Addendum 2

Request for Proposal FY16-0714 Voice Data and Infrastructure Cable

Addendum No. 2 (herein referred to as "Addendum")

This addendum is as follows: RFP Questions/Responses and Attachments Posted June 27, 2016

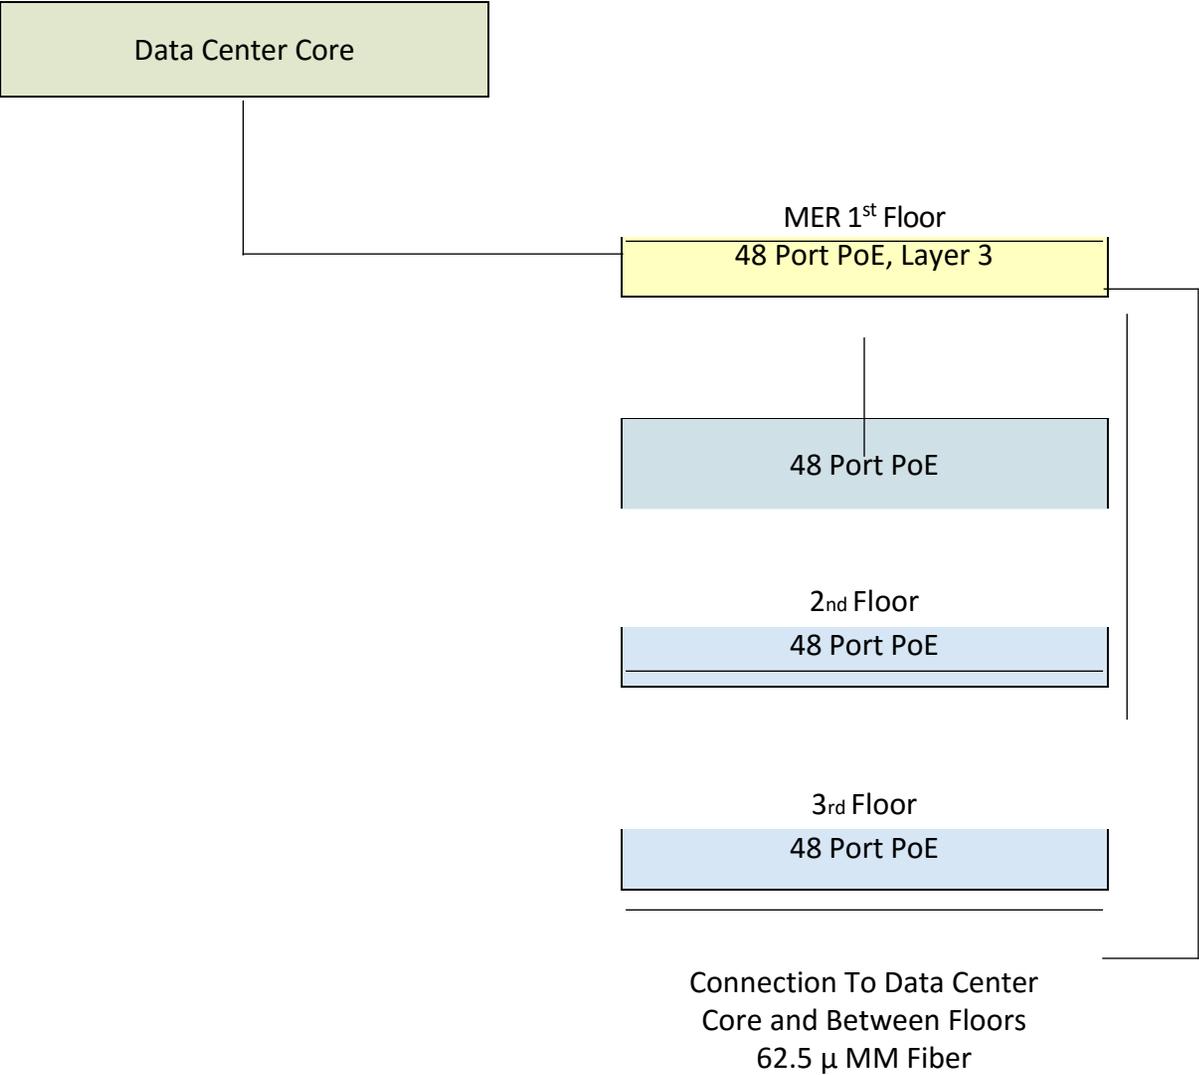
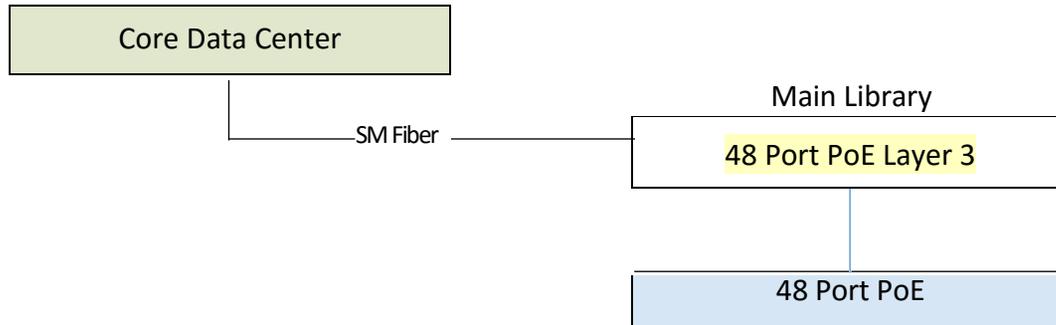
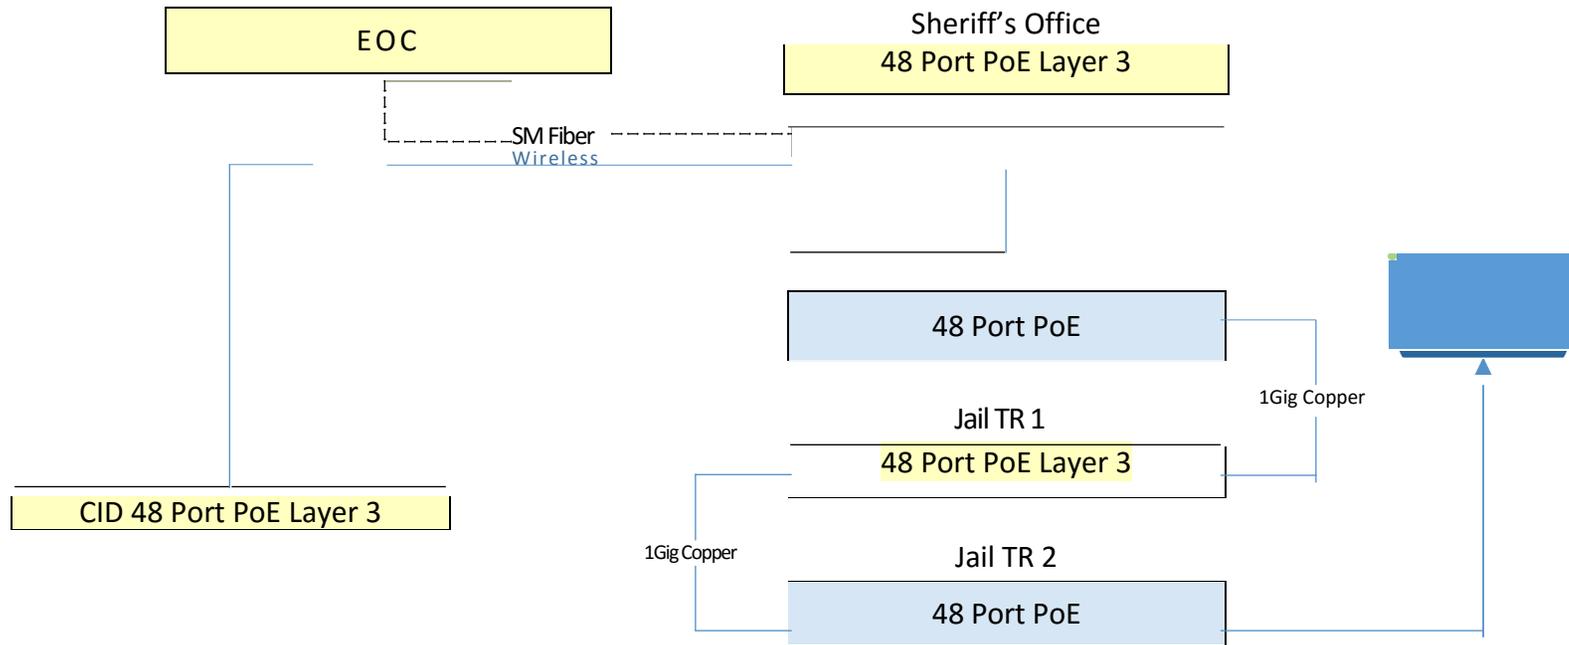
- A10. Please see Drawing T501 for riser diagram details.
- Q11. Please confirm your assessment of which switches are core switches, distribution switches, and access switches in your topology.

- A11. The Core switches are located in the Data Center. Distribution switches are in the MER of each building and are labeled as Layer 3. See Attached diagram. The Core switches are highlighted in green and the distribution switches in yellow.
